Questions and Answers

STRUCTURAL Amendments to Drawings:

END OF ADDENDUM NO. 4

NEW CROATIAN CULTURAL CLUB
615 BARTON STREET
STONEY CREEK ONTARIO

DATE MARCH 2026	DRAWN BY T.M.	DRAWING No. S2.1
PROJECT No. 21279	CHECKED BY R.H. & J.P.C.

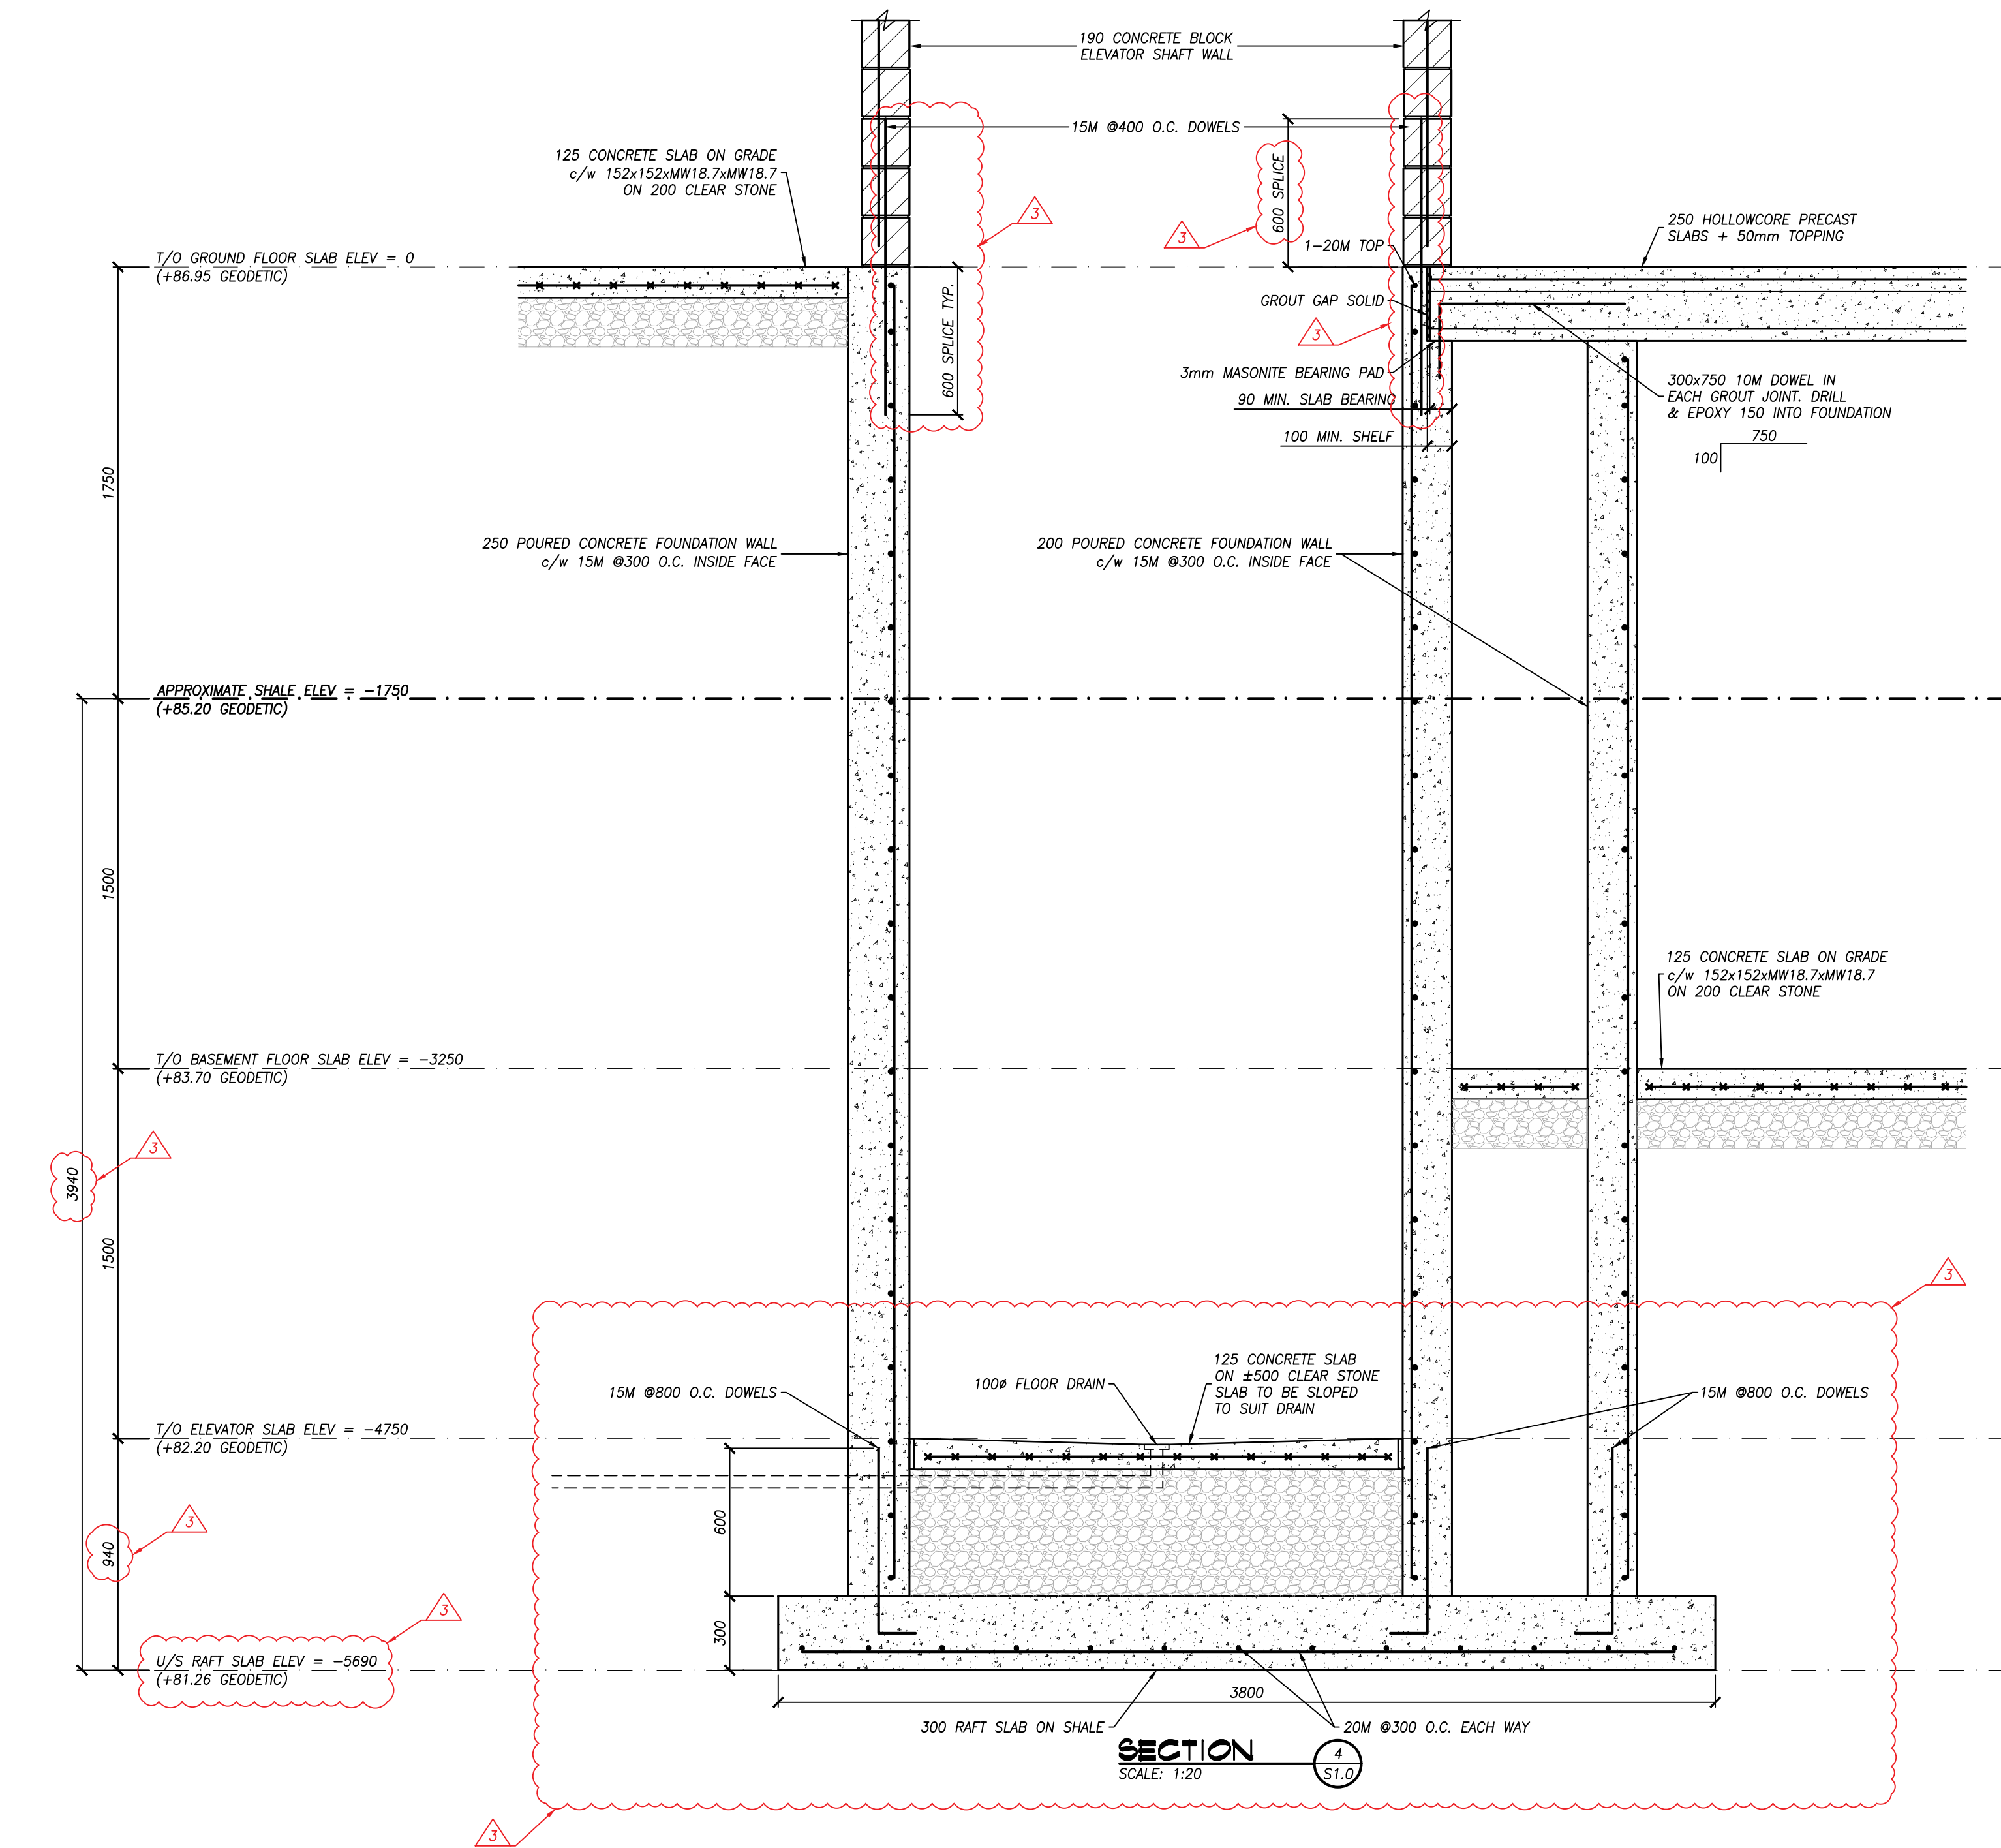
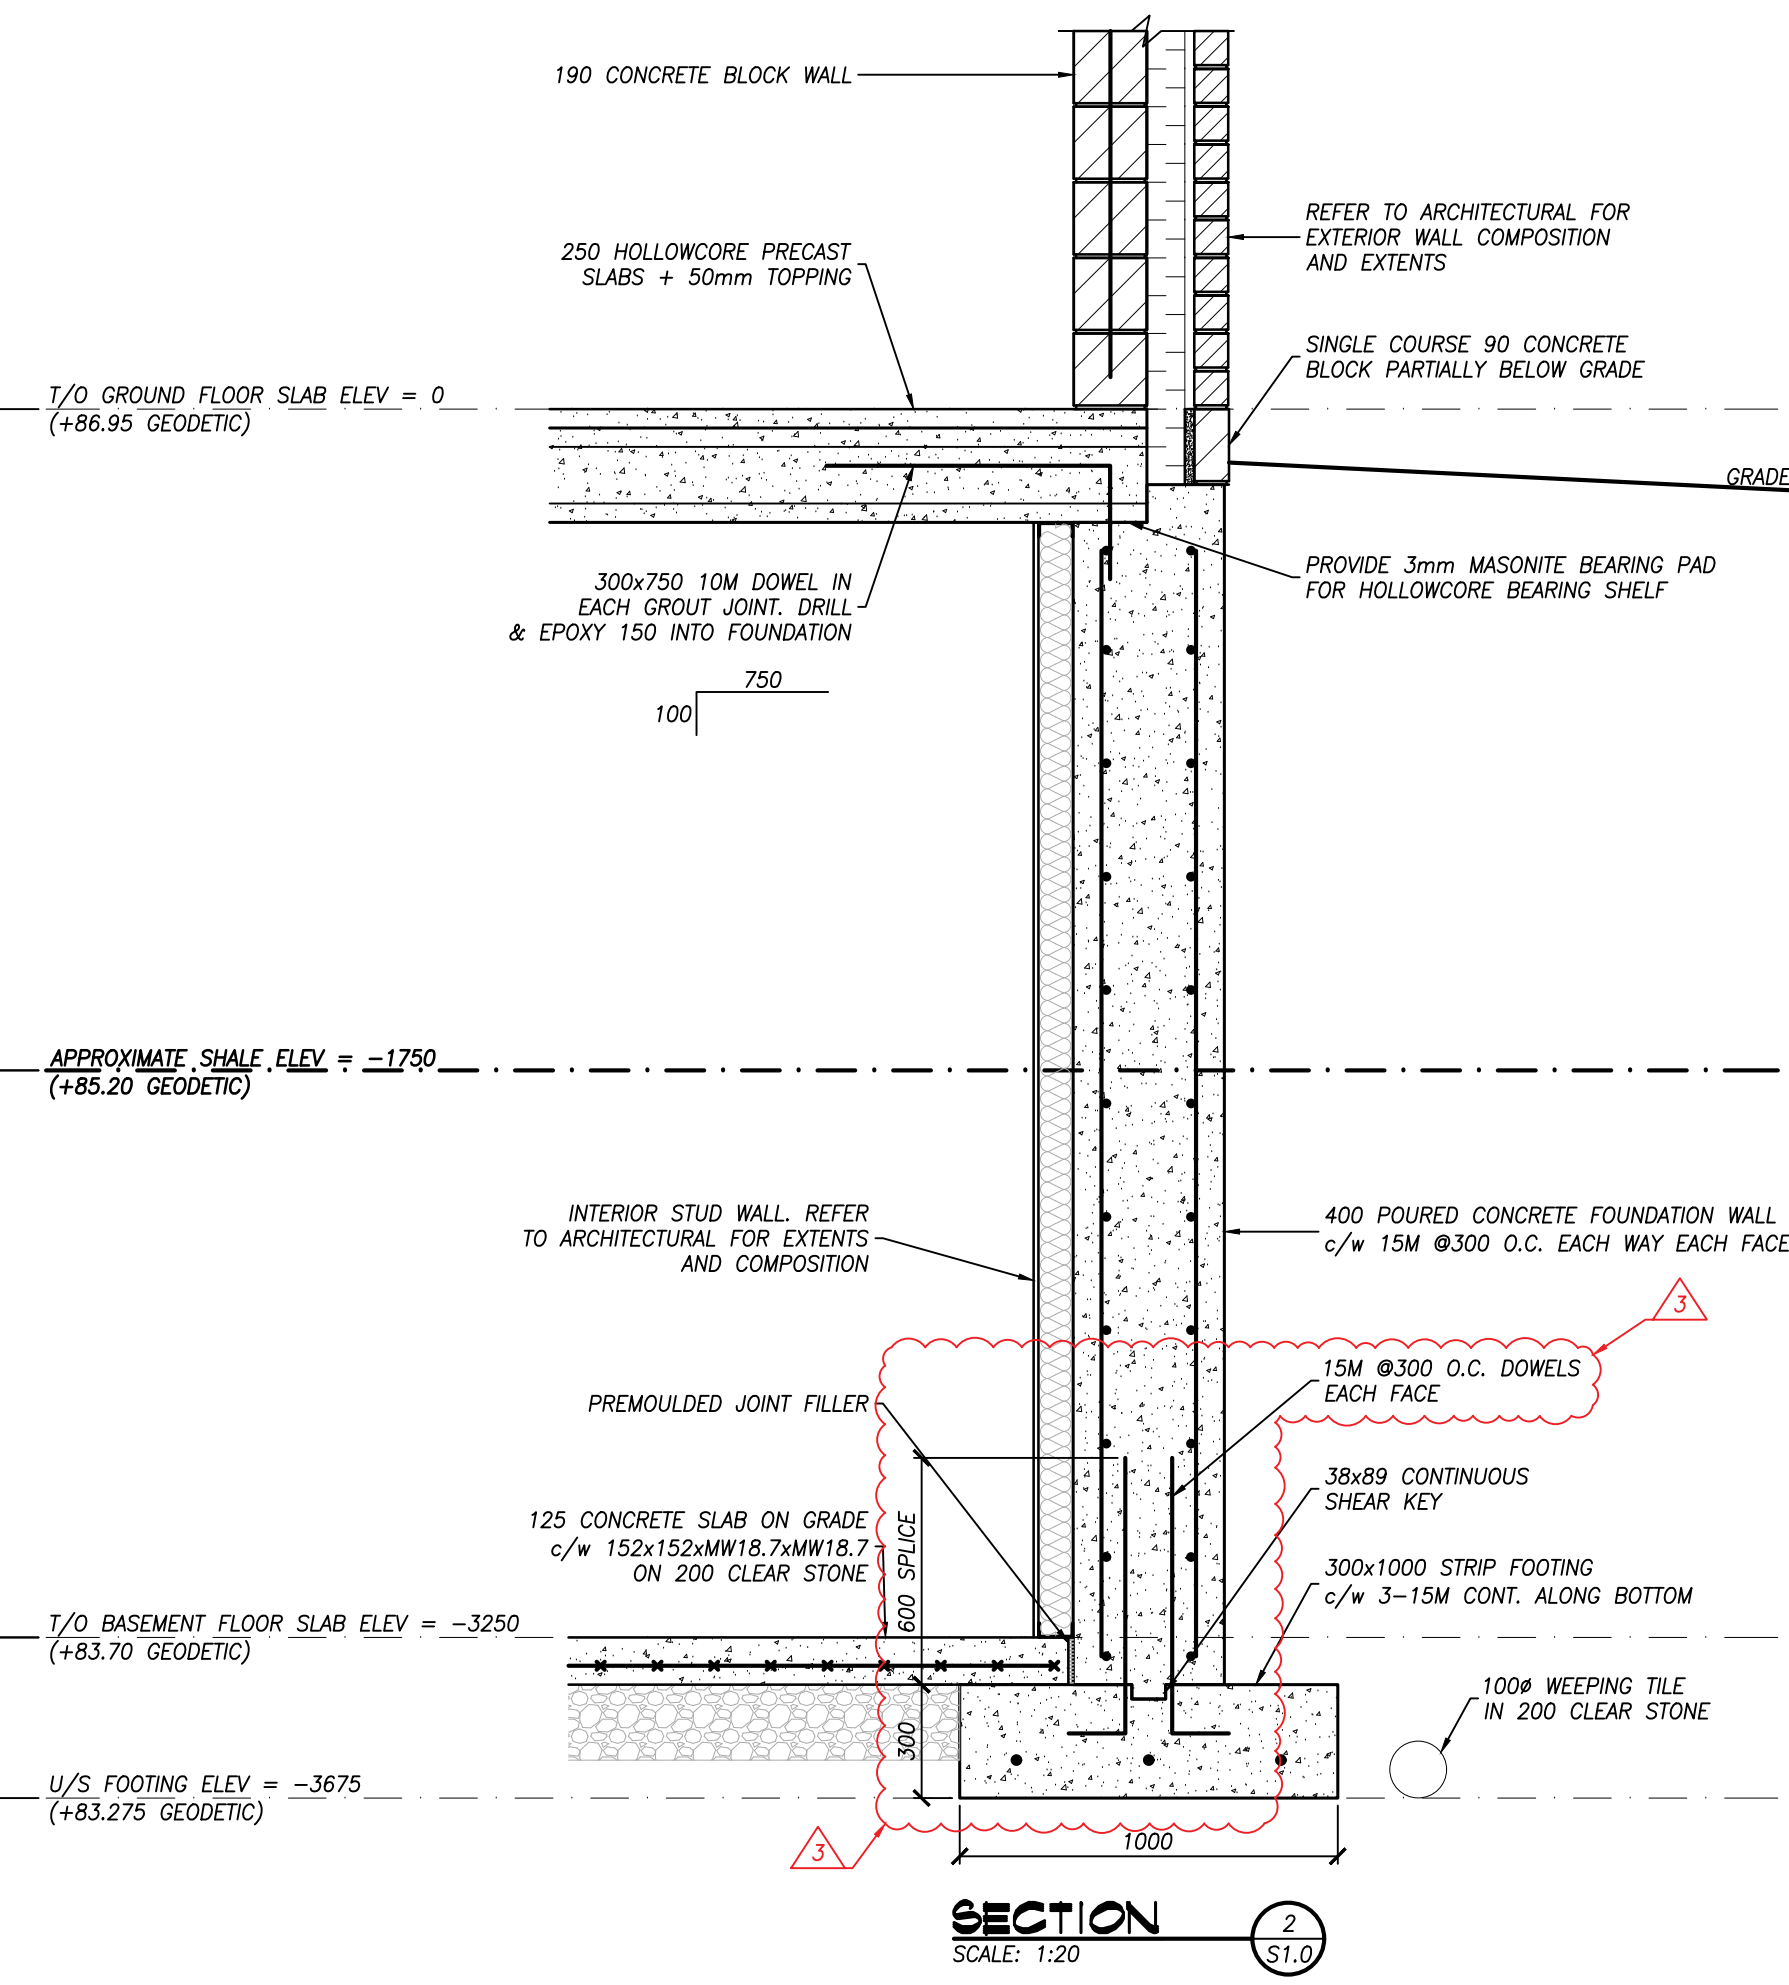
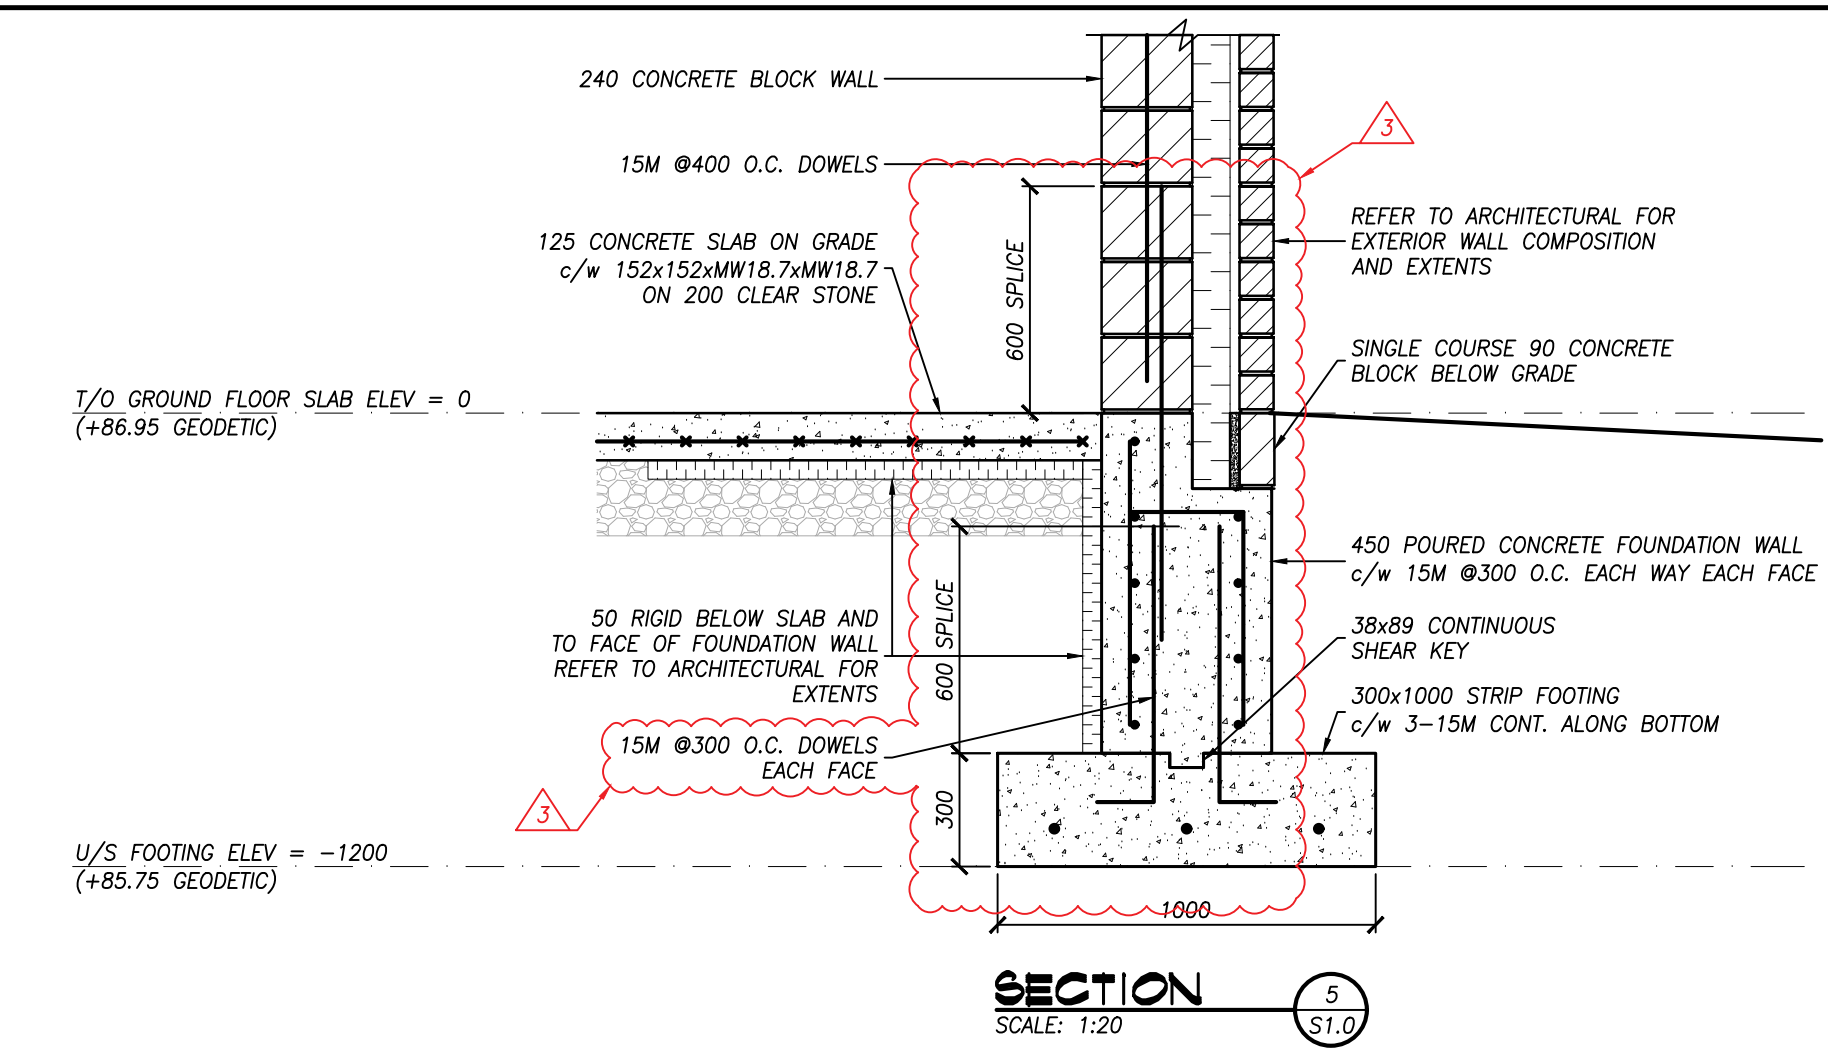
- A. Refer to sheet S1.0:
 - Updated the elevations for the sump pits.
 - Updated the extent of the raft foundation under the elevator shaft.
 - Updated the underside of footing elevations and step-down footings around the sump pits.
- B. Refer to sheet S2.1:
 - Updated section 4/S1.0 to reflect the correct elevations for foundation and slab on grade.
 - Updated the dowels and their splice length on all sections on this sheet.
